Re: ACTION RE: PETITION FROM CEREBRAL PALSY, INC. – SITE PLAN AND DESIGN REVIEW ON PARCEL AL-1149-906, LOCATED AT 2801 S WEBSTER AVENUE

Date: 22 February 2017

Site Plan & Design Review – Staff Comments

Site: 2801 S Webster Avenue (Parcel AL-1149-906, AL-1149-337, AL-1149-338)
Development: CP Center Addition and Remodel
Developer Representatives: Cerebral Palsy, Inc. – Jon Syndergaard – Executive Director
 Sommerville – Jason Hale, AIA, LEED AP BD+C – Project Architect
 Robert E. Lee & Associates, Inc. – Patrick H. Kuehl, P.E. – Civil/Municipal Project Manager

UTILITY PLAN

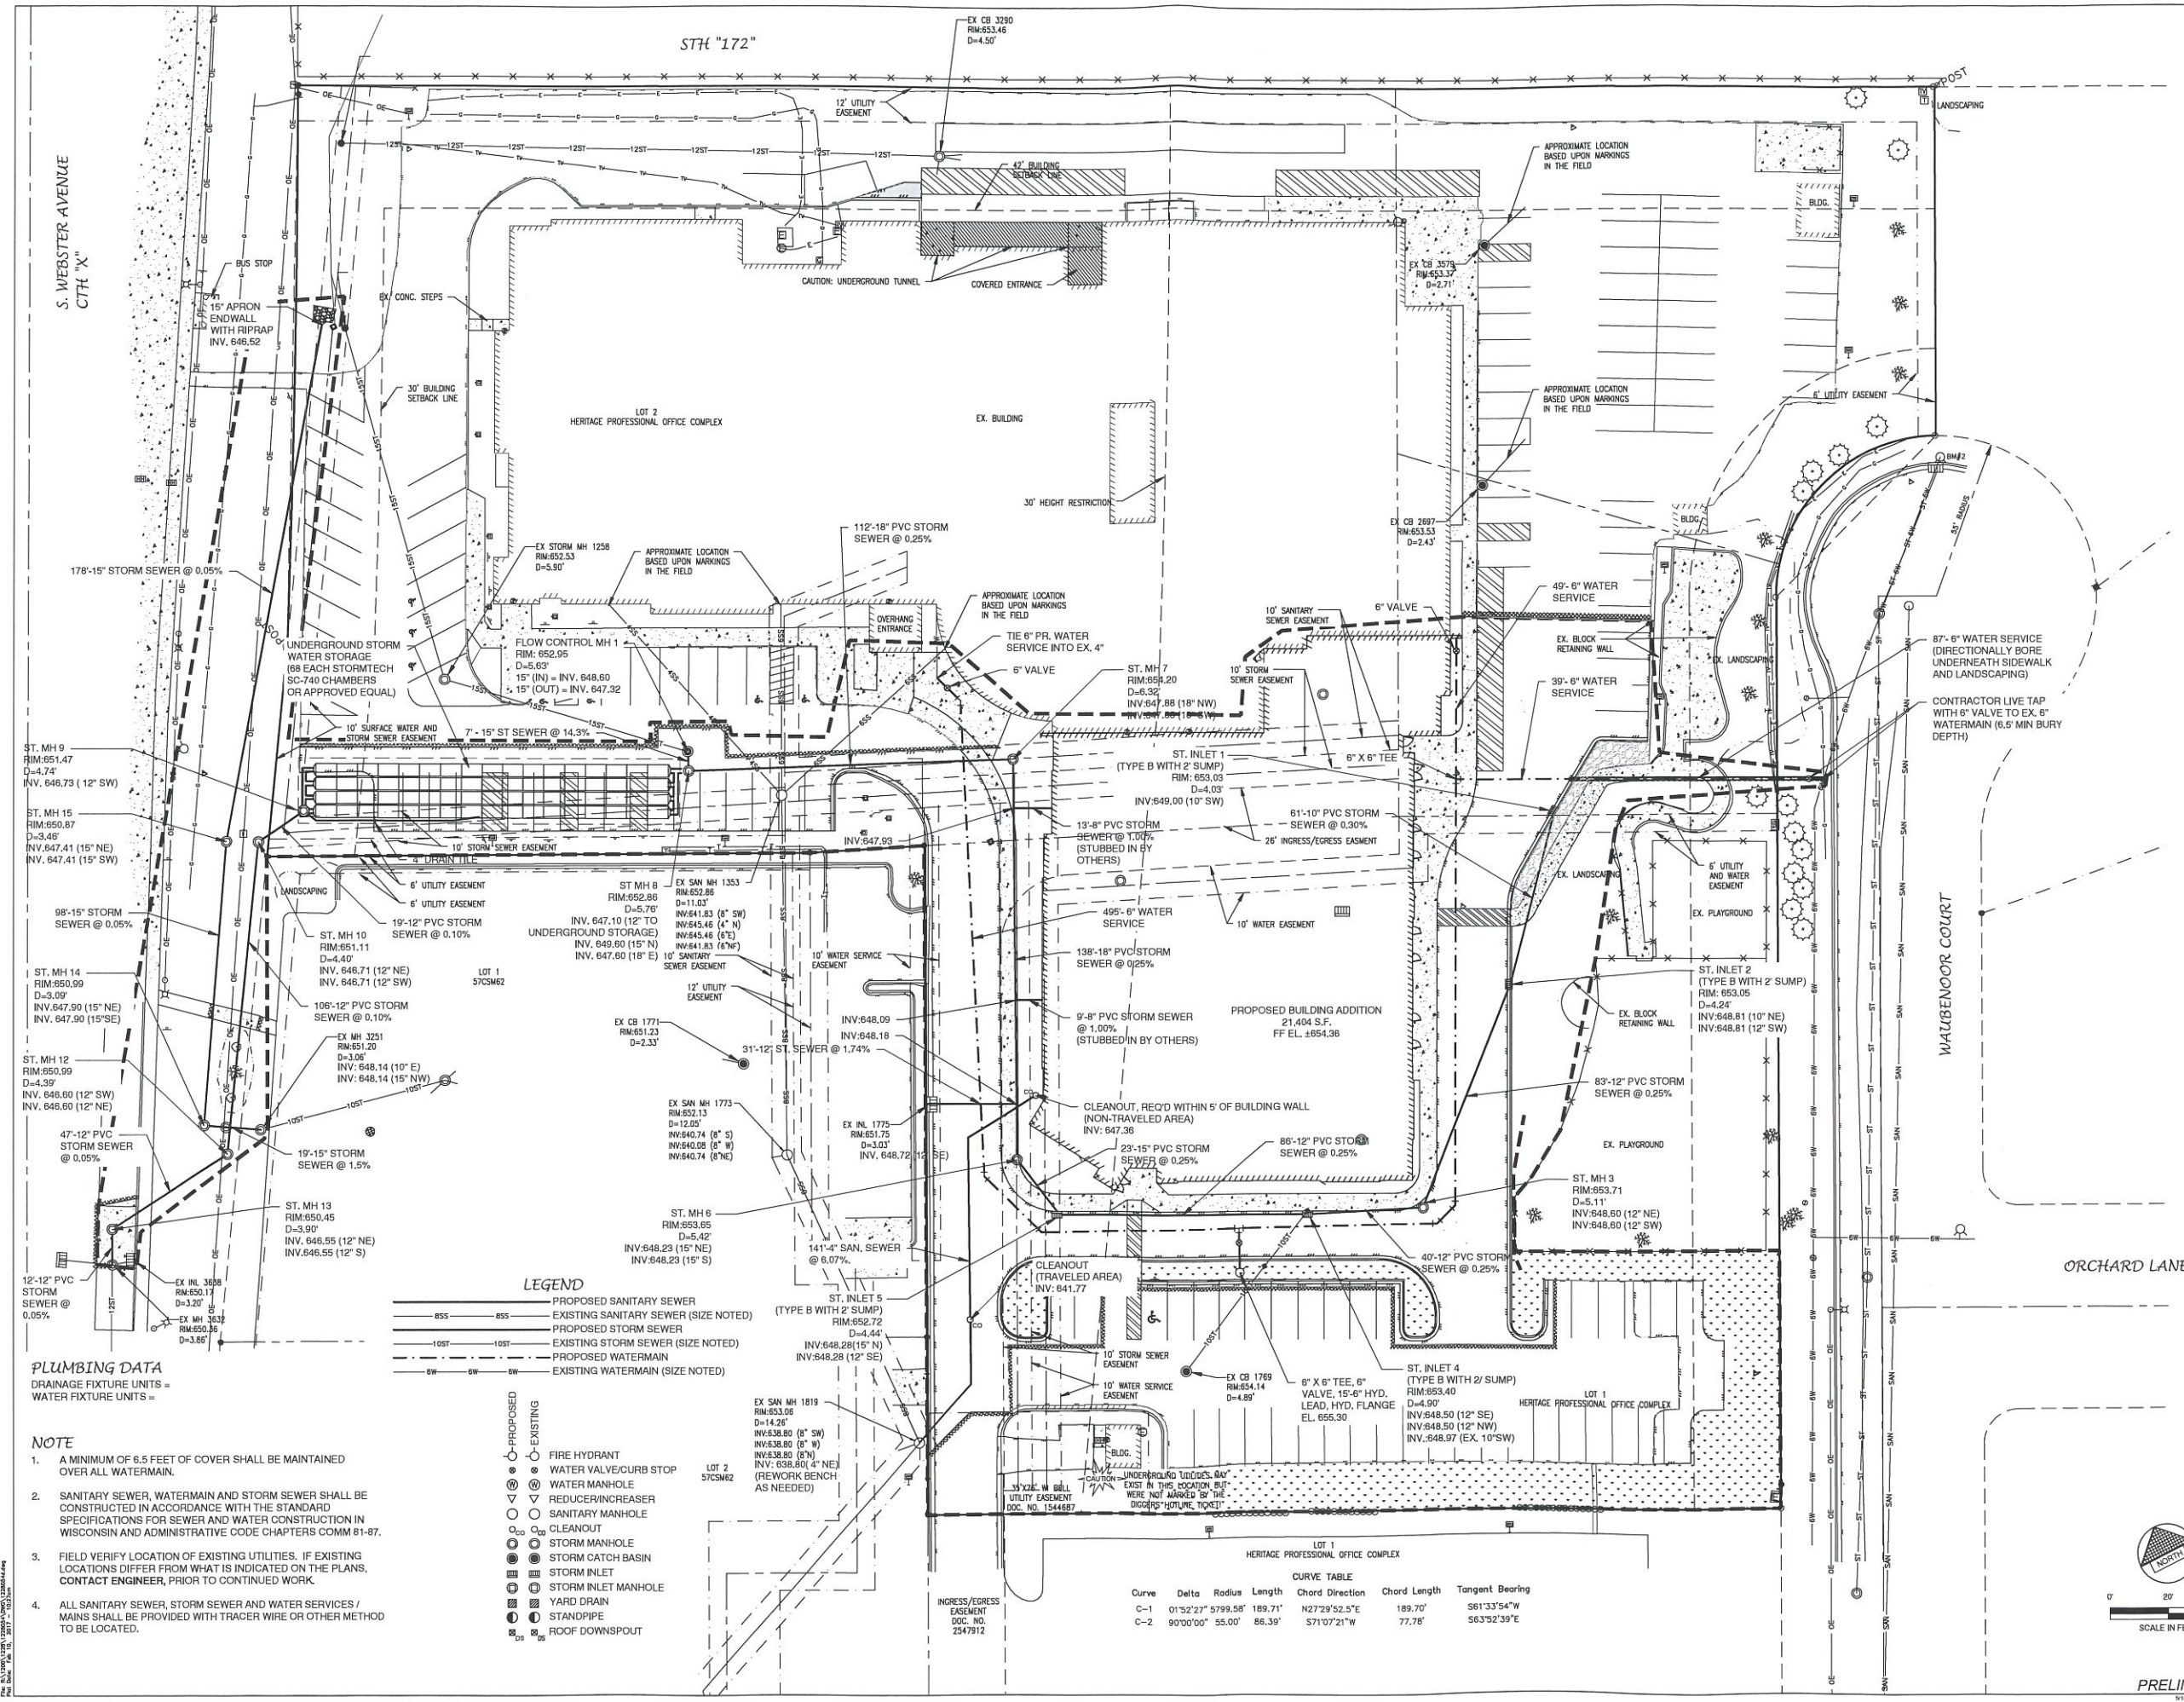
3. The changes to the driveways and roads is acceptable. We only want to ensure that all buildings have adequate access.
4. A new 6" water service is planned to replace the existing 4" service. This will be a CP project cost, including the piping in Waubenoer Drive to tie into the existing main. A Public Works utility permit will need to be obtained prior to this work.

UNDERGROUND CHAMBER AND CONTROL MANHOLE DETAILS

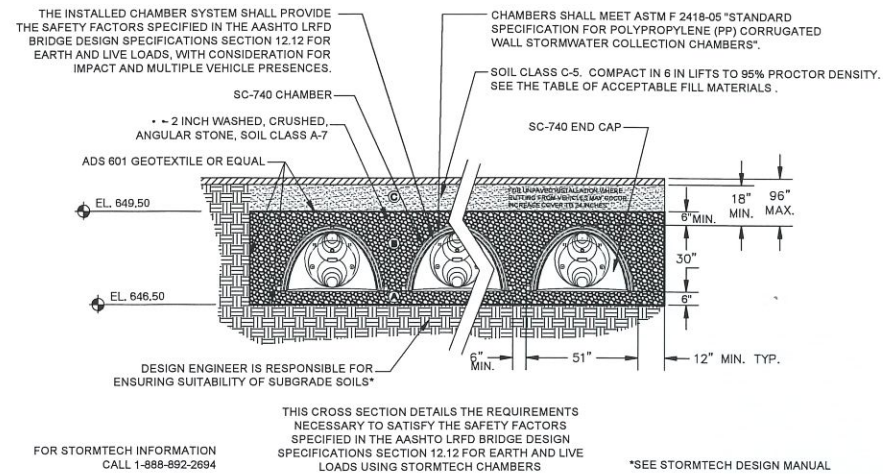
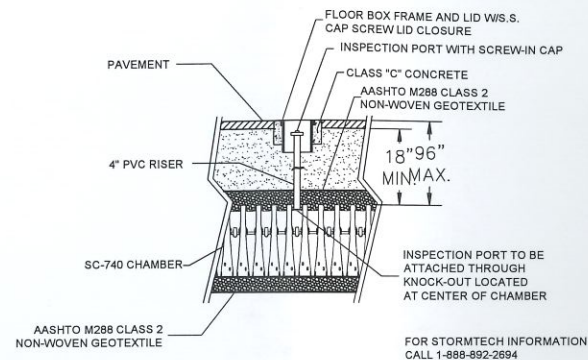
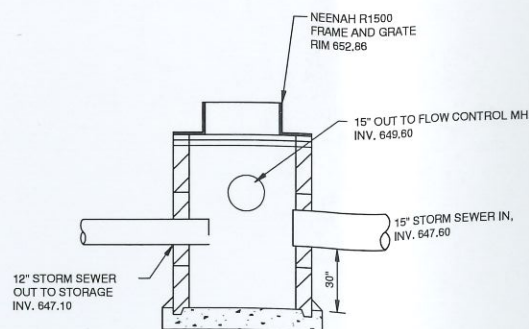
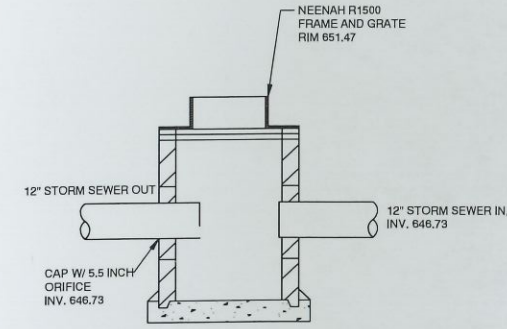
5. Drawings of the underground storage system will be required during stormwater permit issuance.

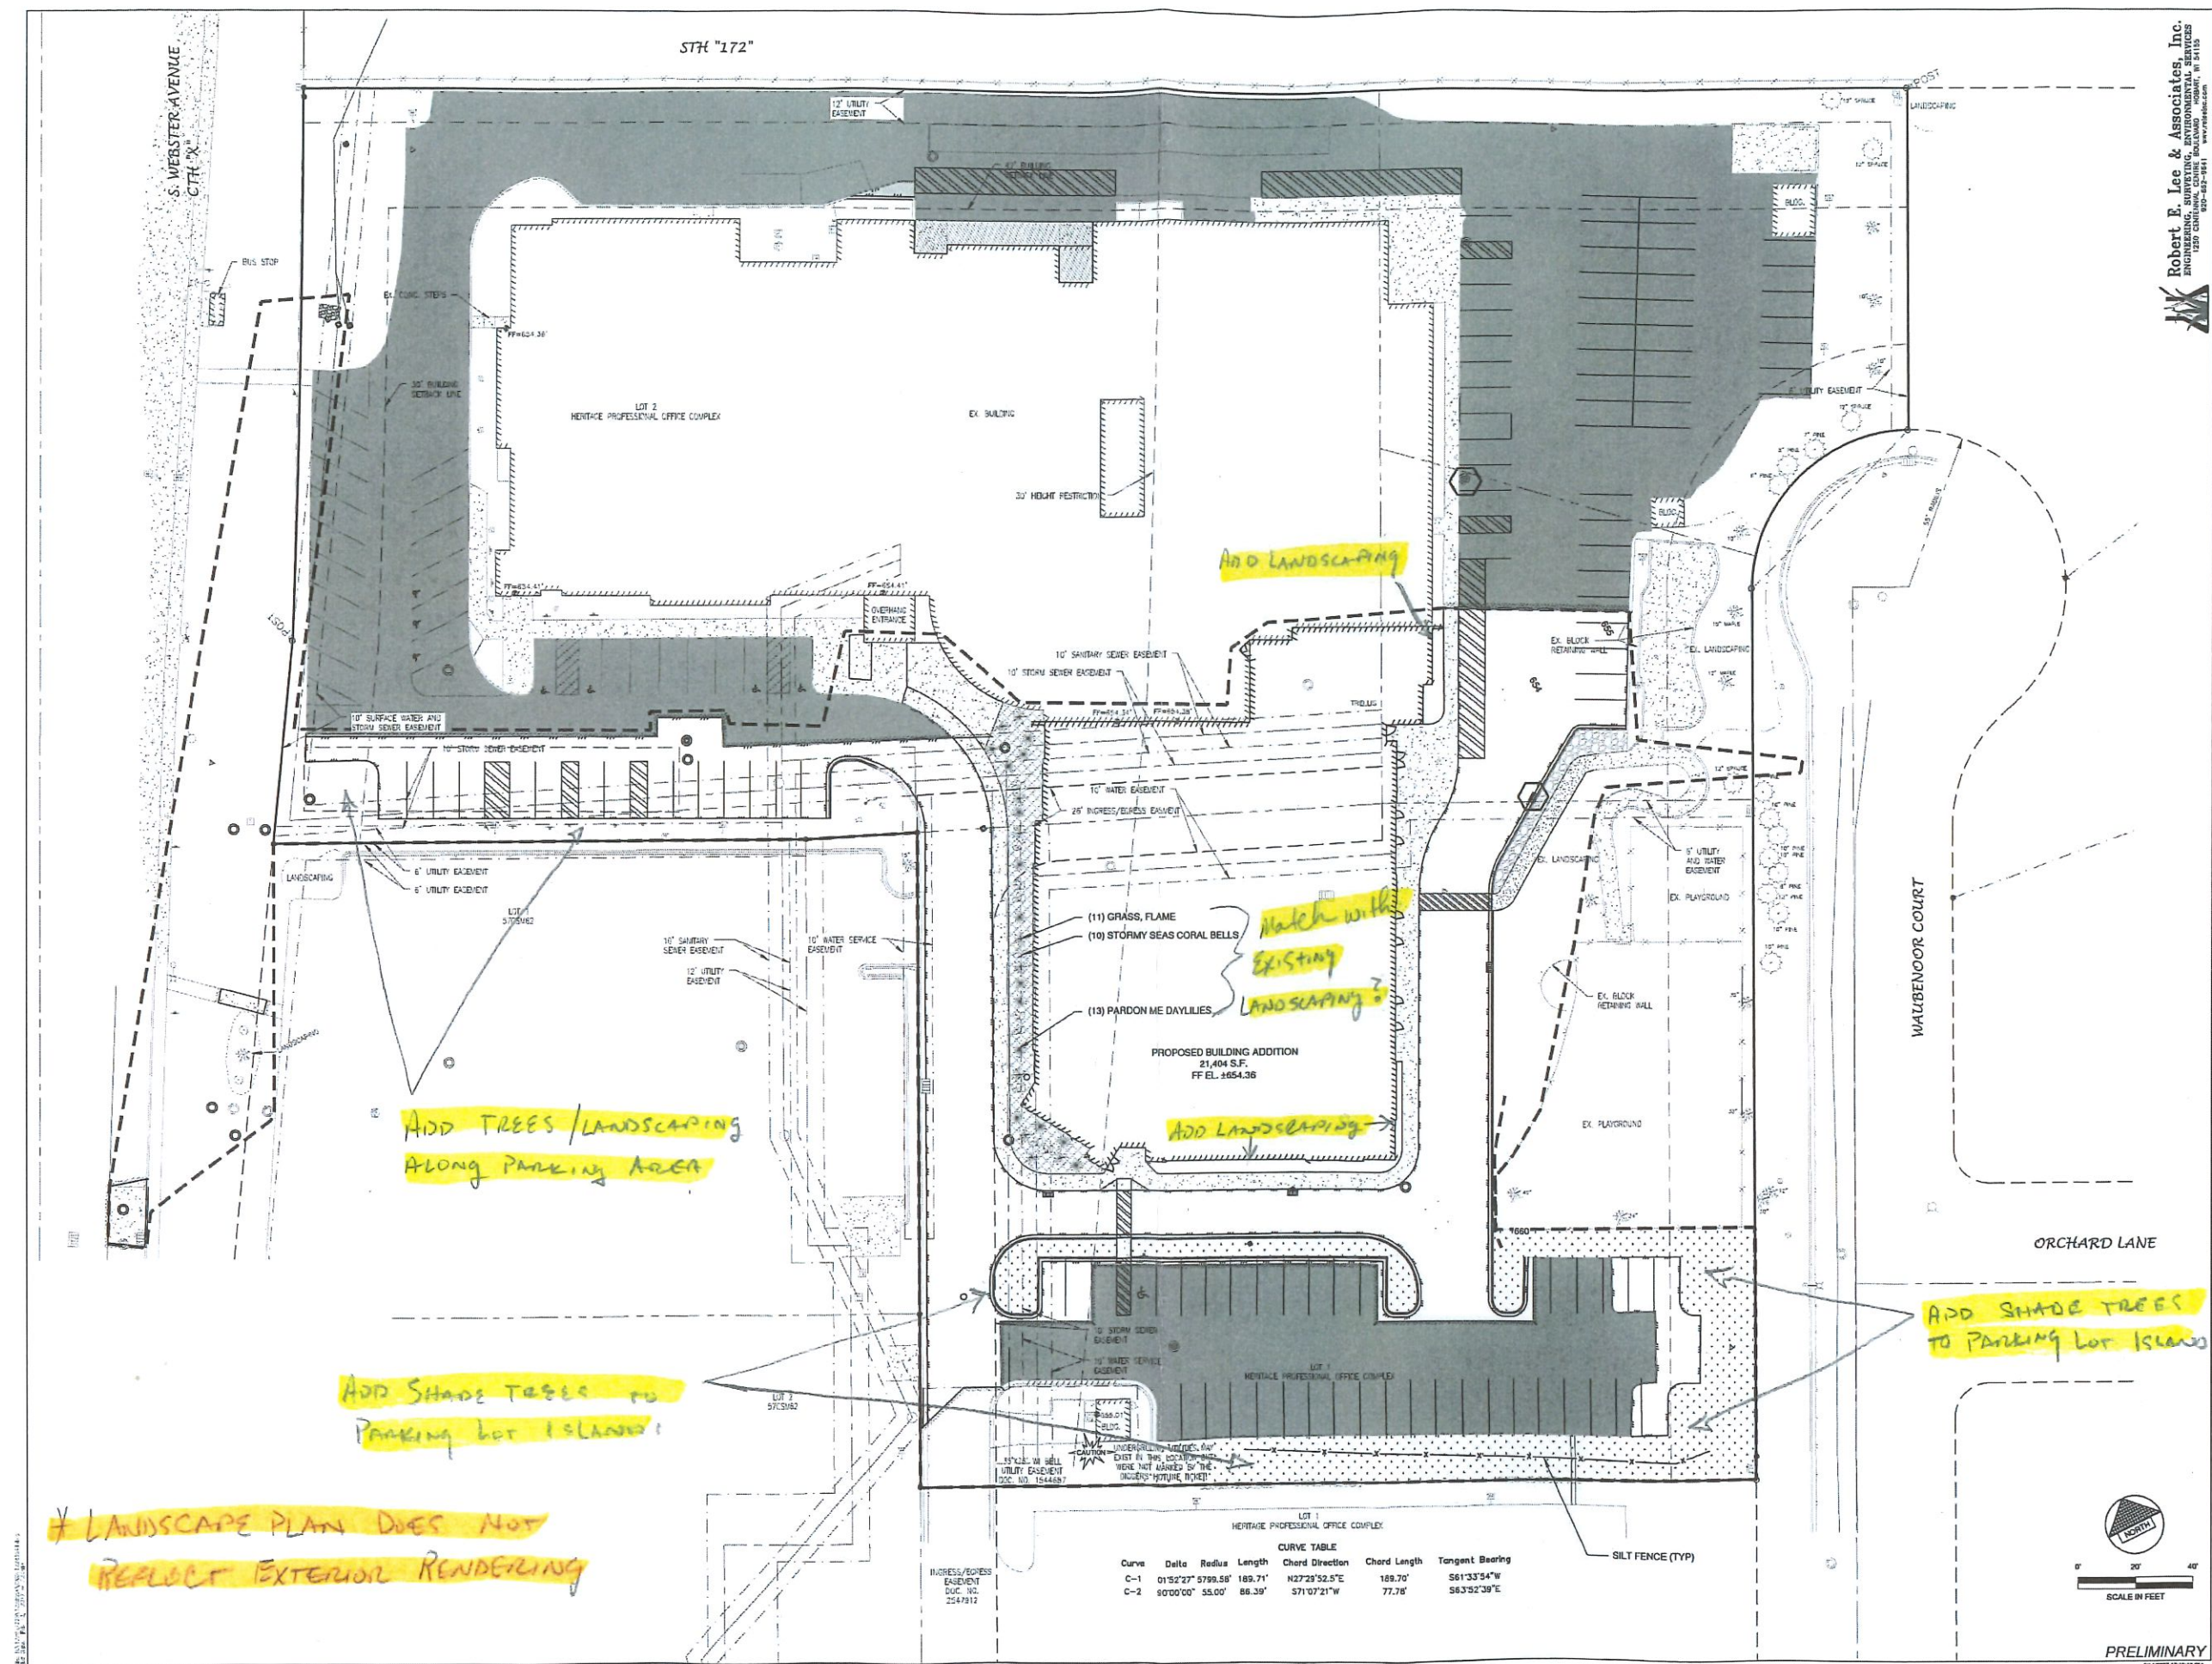
- The current Fire Department Connection for the old building is in a bad location on the NE corner of the building. GBMFD will like a private hydrant to be located closer to the FDC or have the FDC relocated during remodel to a location closer to a fire hydrant.

- A Knox Box will be required to be placed on the new entrance to the building. The Knox Box brand locking boxes can be purchased by calling (920) 448-3280 and requesting a Knox Box brand locking box packet or by going online at Knox Box.com and ordering online (please use the City of Green Bay as the jurisdiction). IFC #506.1 and 506.1.1. IF the remodel will contain a sprinkler control room accessible from the exterior a Knox box would also be required to be placed adjacent to the exterior door. IFC #506.1 and 506.1.1.

- IF there is a change to the FDC connection, GBFD requires that all FDC and Standpipe connections are five inch Storz brand connections. If the FDC or Standpipe connection is higher than 30 inches above finished grade, then you will be required to install thirty degree down angle connection on the five in Storz connection. IFC 903.3.7
